STATE OF MAINE
DEPARTMENT OF TRANSPORTATION
16 STATE HOUSE STATION
AUGUSTA, MAINE 04333-0016

March 21, 2014
Subject: **Augusta Phase 2**
State Project No: 020118.20
Amendment No. 1

Make the following change to the Bid Documents:

SKS-03
AMENDMENT #1

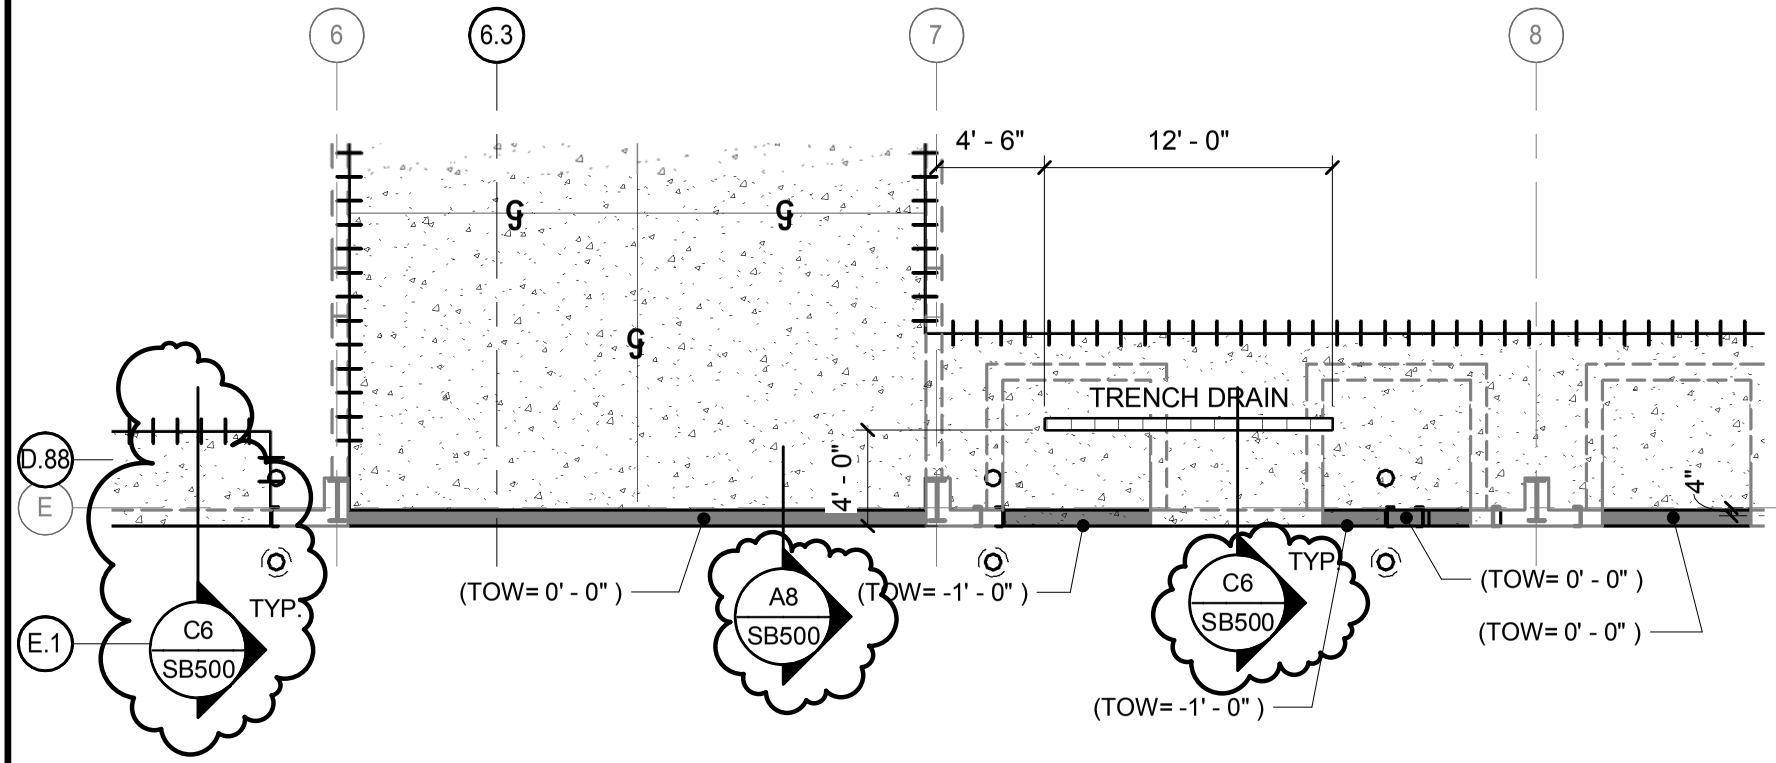
On plan Sheet SB100C Titled “STRUCTURAL - FOUNDATION PLAN – AREA-C”
ADD: DETAIL A8/SB500. AMENDMENT-1 SKETCHES SKS-03 AND SKS-04

SKS-04
AMENDMENT #1

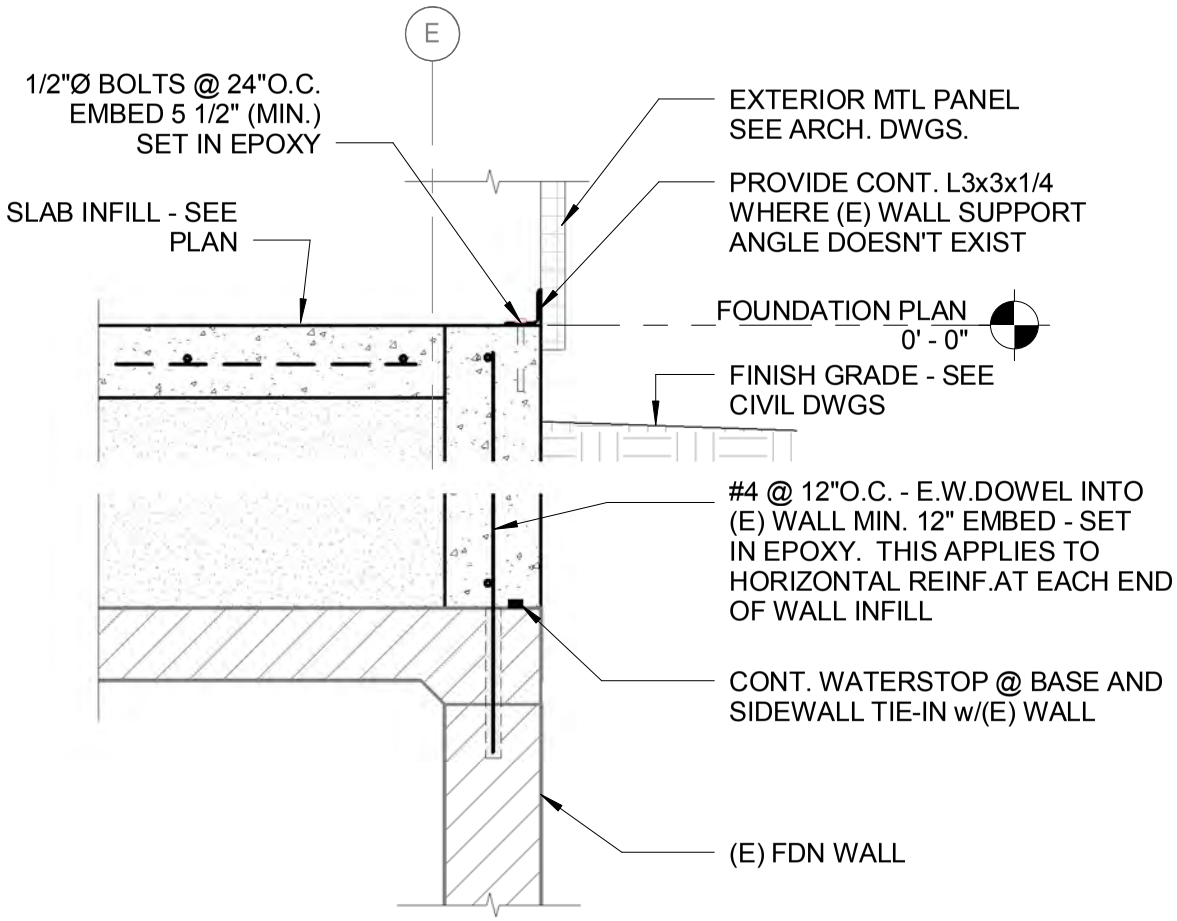
On plan Sheet SB500 Titled “STRUCTURAL – FOUNDATION DETAILS”
ADD: DETAIL A8. AMENDMENT-1 SKETCH SKS-04

SKS-05
AMENDMENT #1

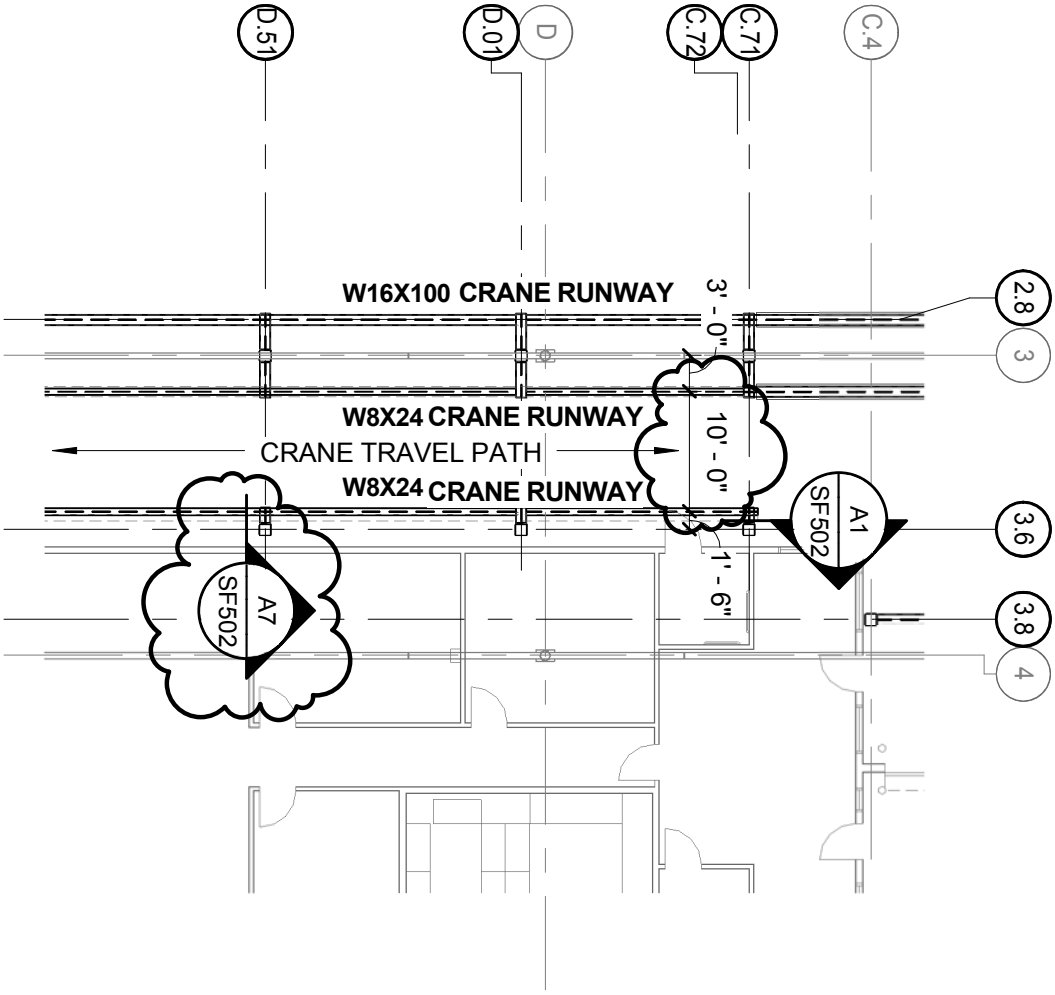
On plan Sheet SF100 Titled “STRUCTURAL – CRANE FRAMING PLAN”
DELETE THE DIMENSION 10’-6”, LOCATED WITHIN COLUMN LINES 3 & 4 AND C.4 & D.
ADD: AMENDMENT-1 SKETCHES SKS-05 AND SKS-06

SKS-07
AMENDMENT #1

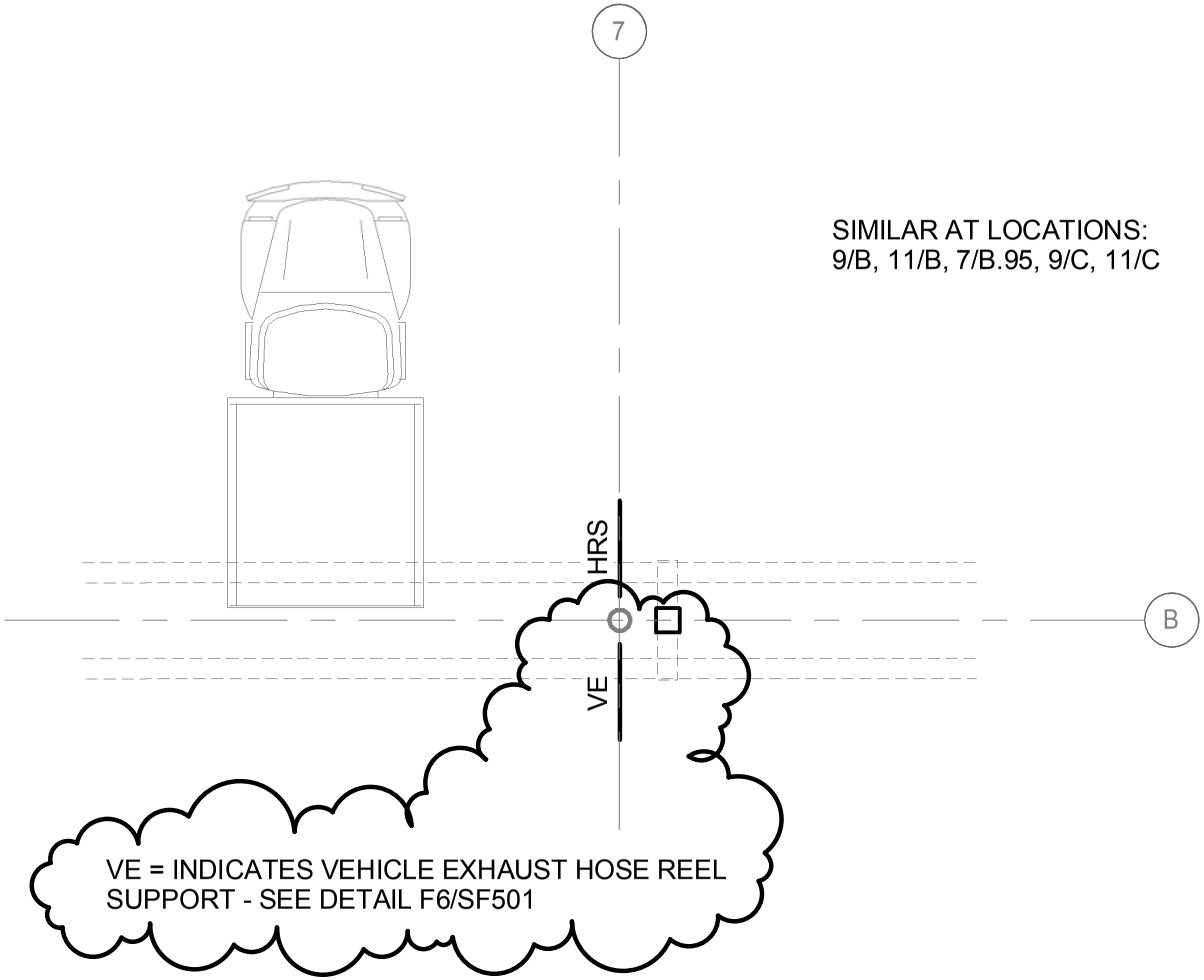
On plan Sheet SF100B Titled “STRUCTURAL - FRAMING PLAN – AREA-B”
ADD: VEHICLE EXHAUST HOSE REEL SUPPORT FRAMING TO LOCATIONS 7/B, 7/B.95, 9/B, 9/C, 11/B AND 11/C. AMENDMENT-1 SKETCH SKS-07

SKS-08
AMENDMENT #1

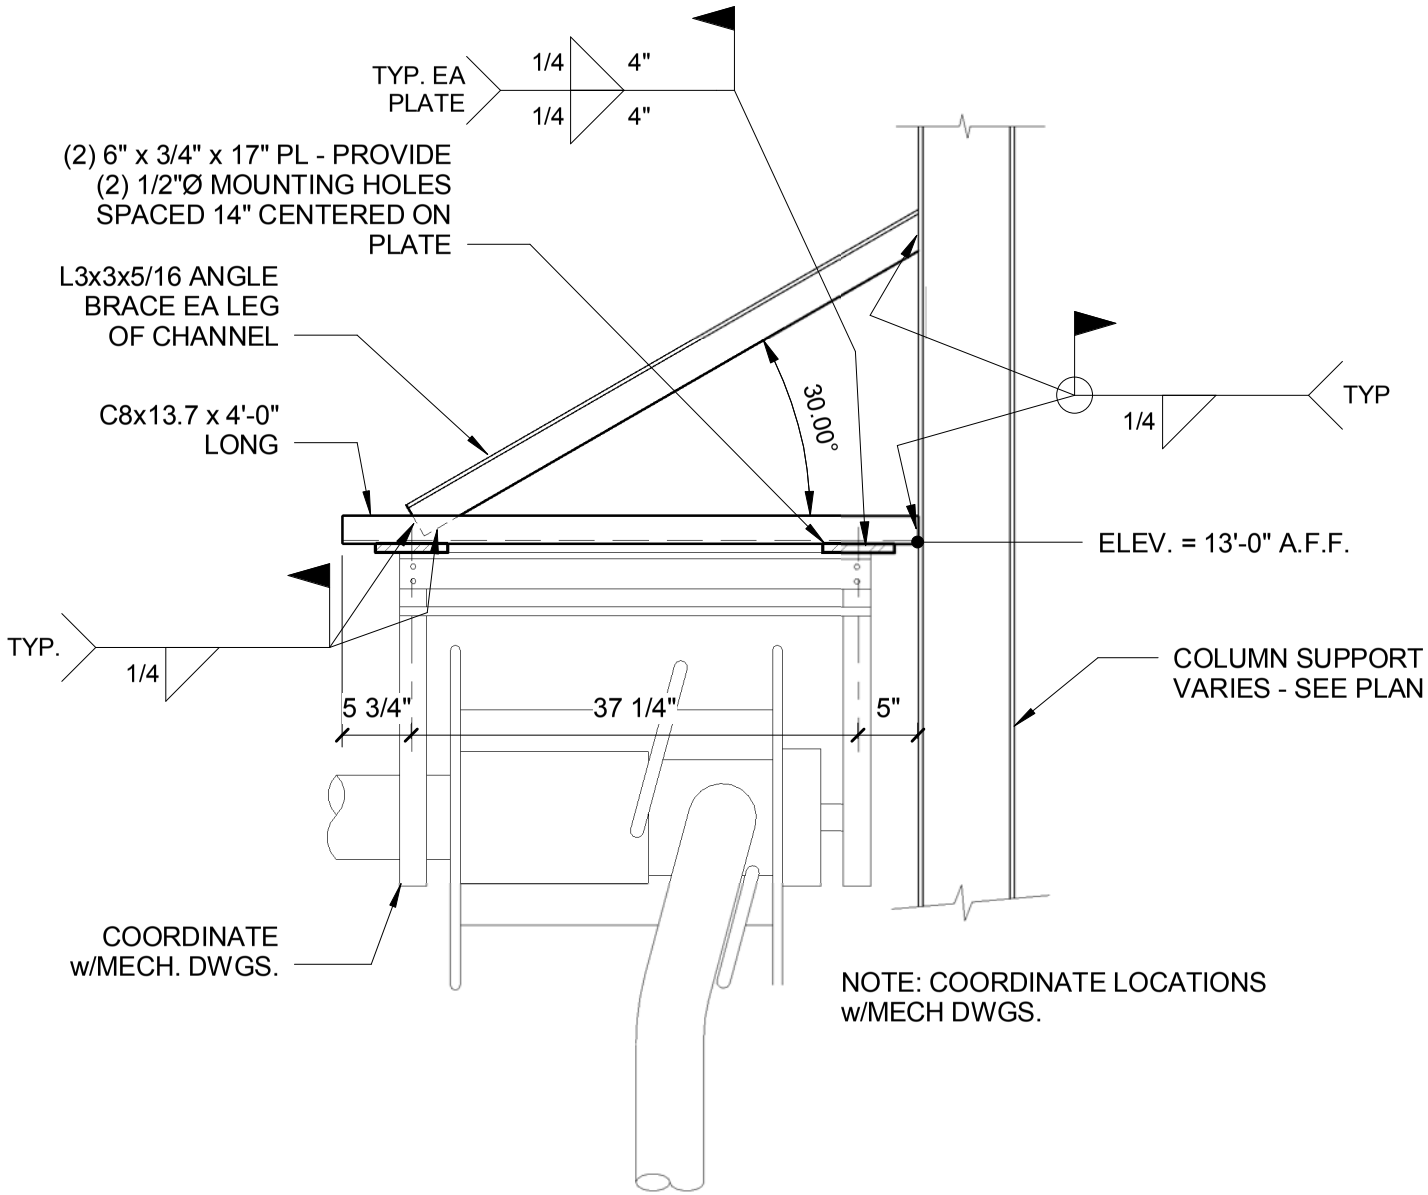
On plan Sheet SF501 Titled "STRUCTURAL - DETAILS"
ADD: DETAIL F6 – TYPICAL VEHICLE EXHAUST HOSE REEL SUPPORT FRAMING DETAIL. AMENDMENT-1 SKETCH SKS-08

SKS-09
AMENDMENT #1

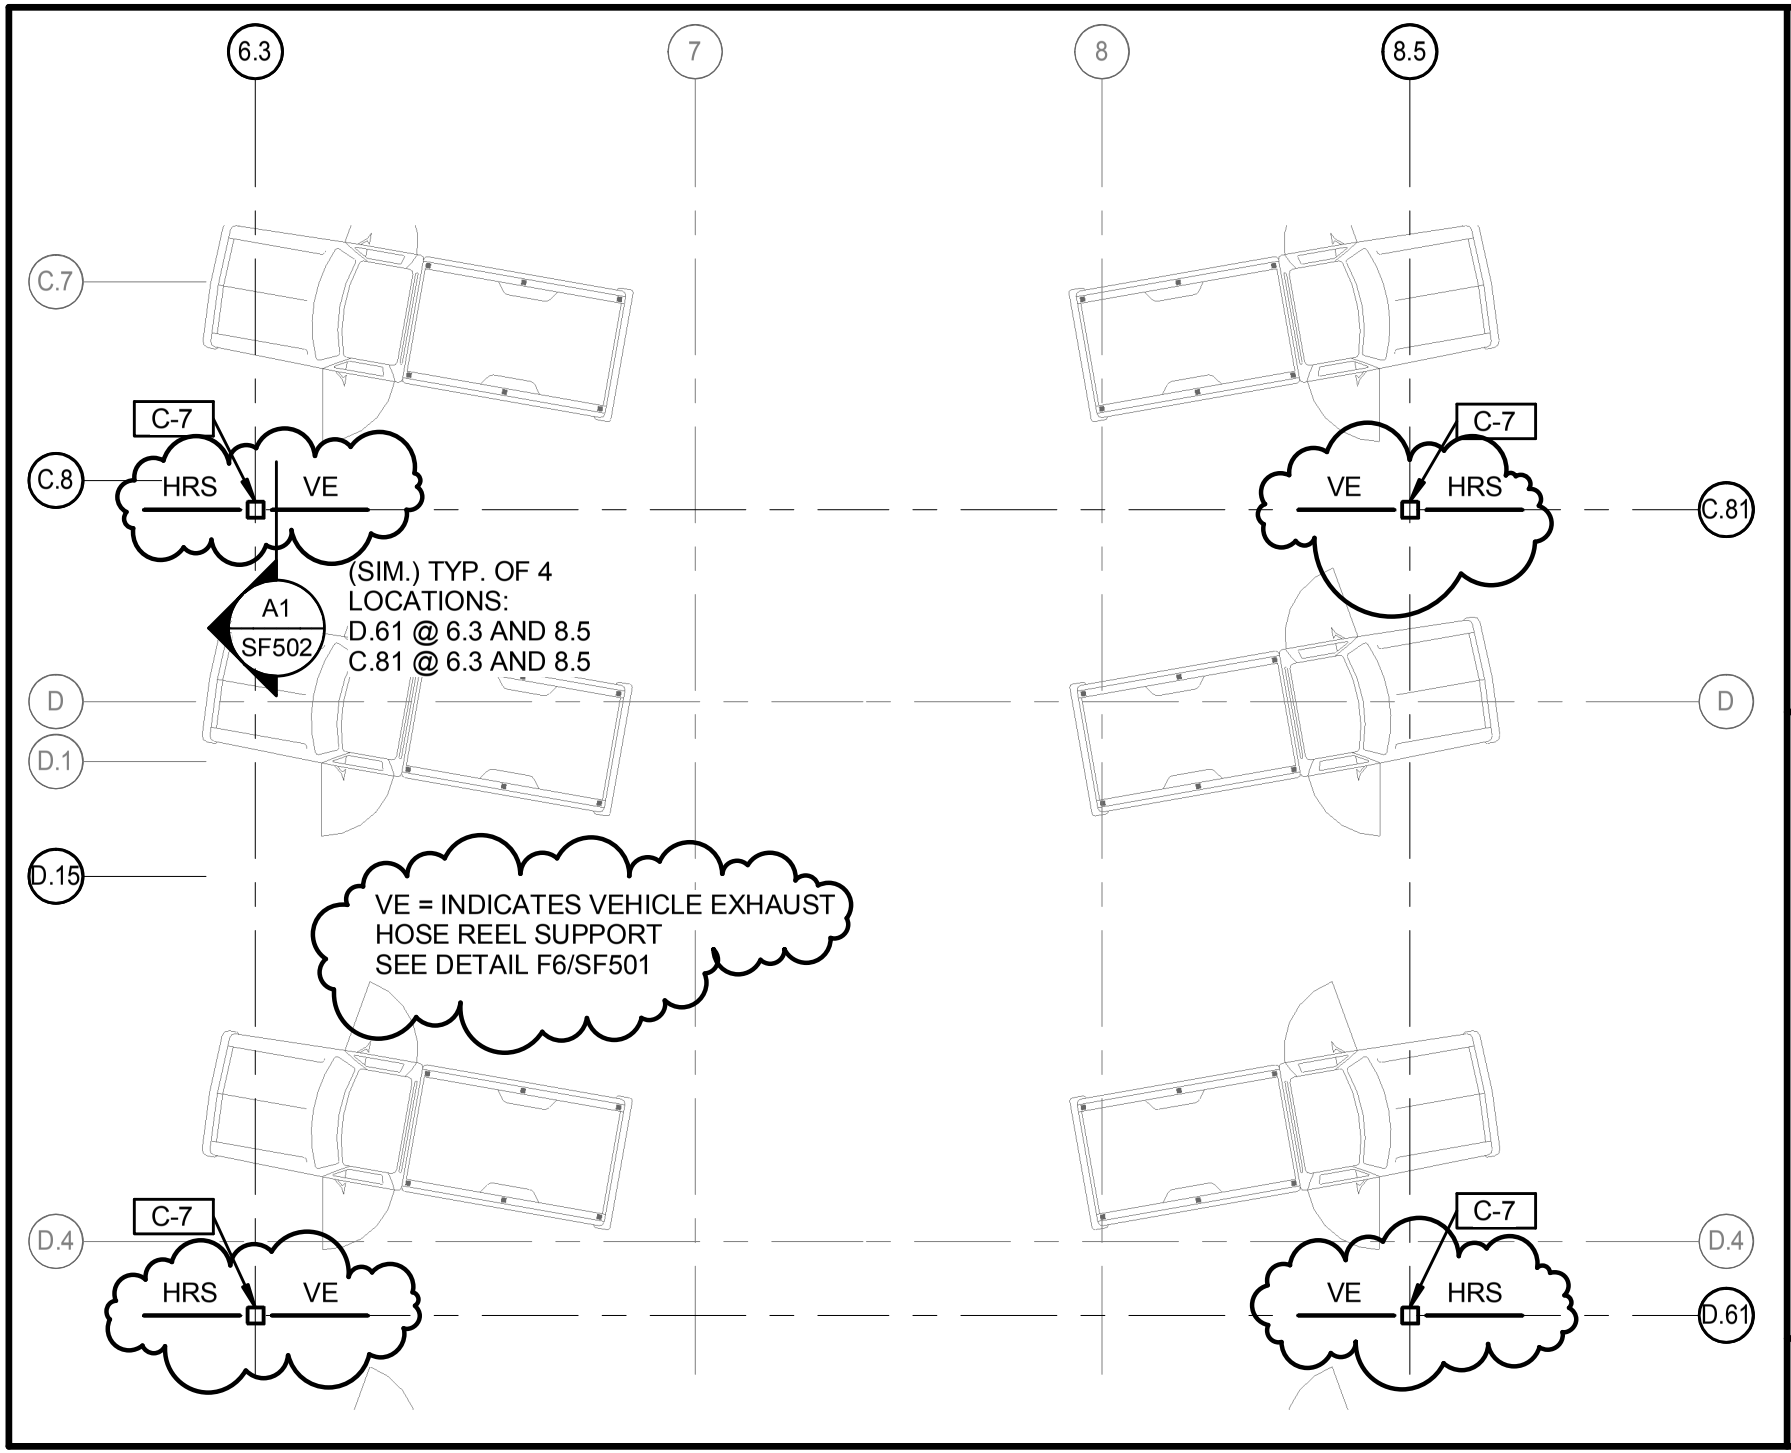
On plan Sheet SF100C Titled “STRUCTURAL - FRAMING PLAN – AREA-C”
ADD: VEHICLE EXHAUST HOSE REEL SUPPORT FRAMING TO LOCATIONS 6.3/C.81, 6.3/D.61, 8.5/C.81 AND 8.5/D.61. AMENDMENT-1 SKETCH SKS-09

SKS-10
AMENDMENT #1

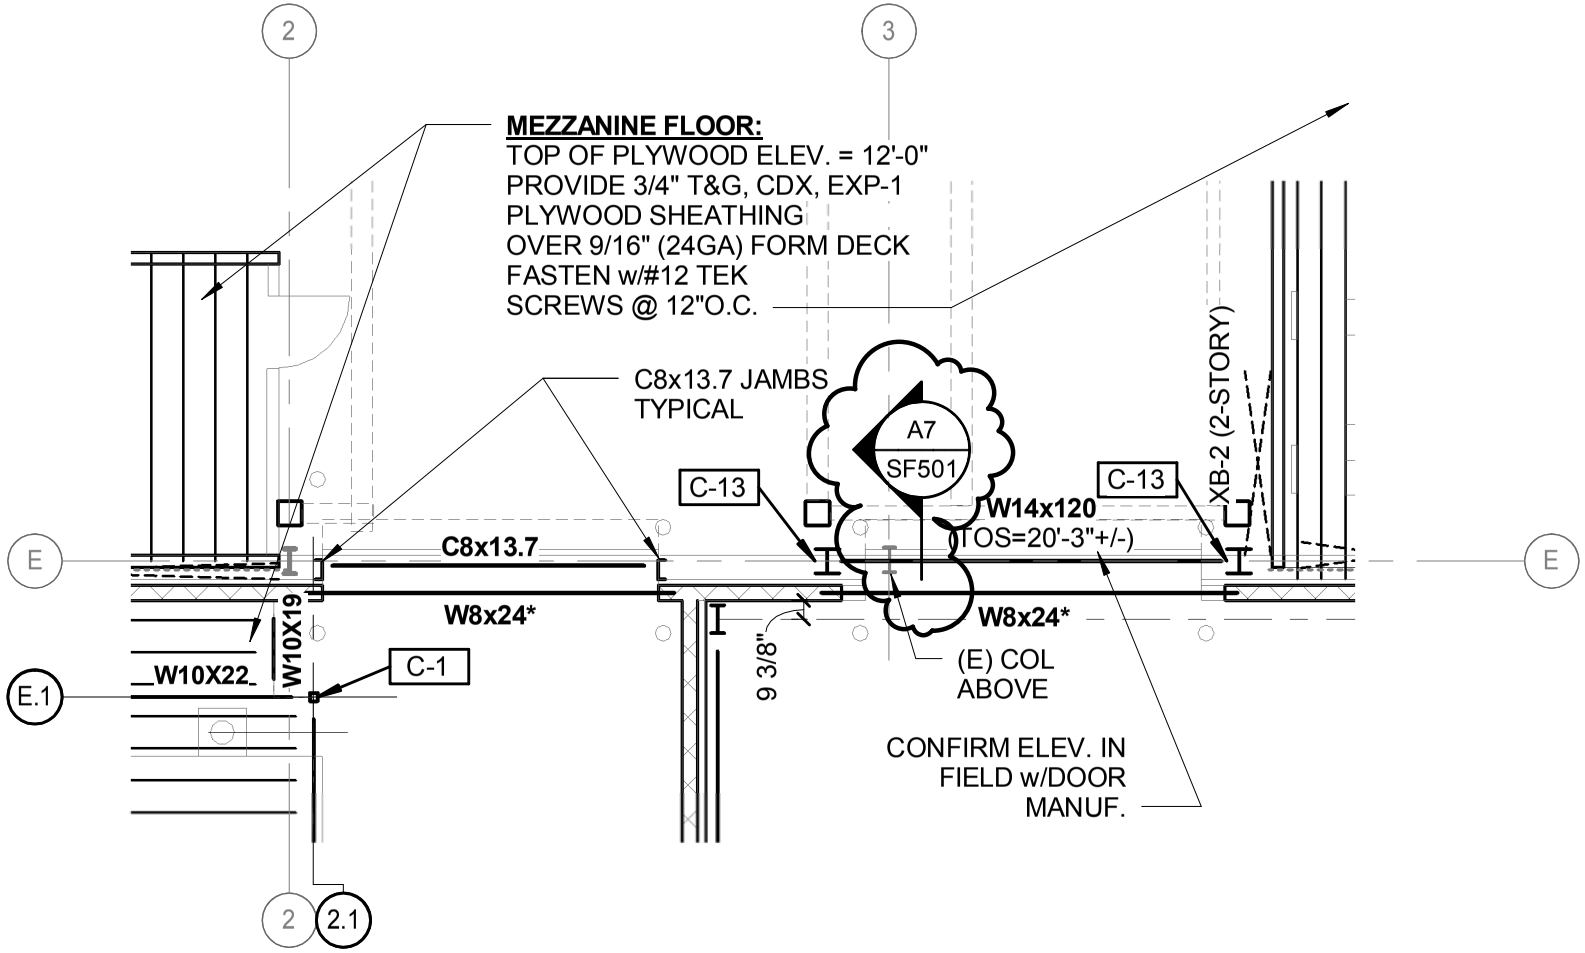
On plan Sheet SF100C Titled “STRUCTURAL - FRAMING PLAN – AREA-C”
ADD: SECTION MARKER FOR DETAIL A7/SF501 AMENDMENT-1 SKETCH SKS-10
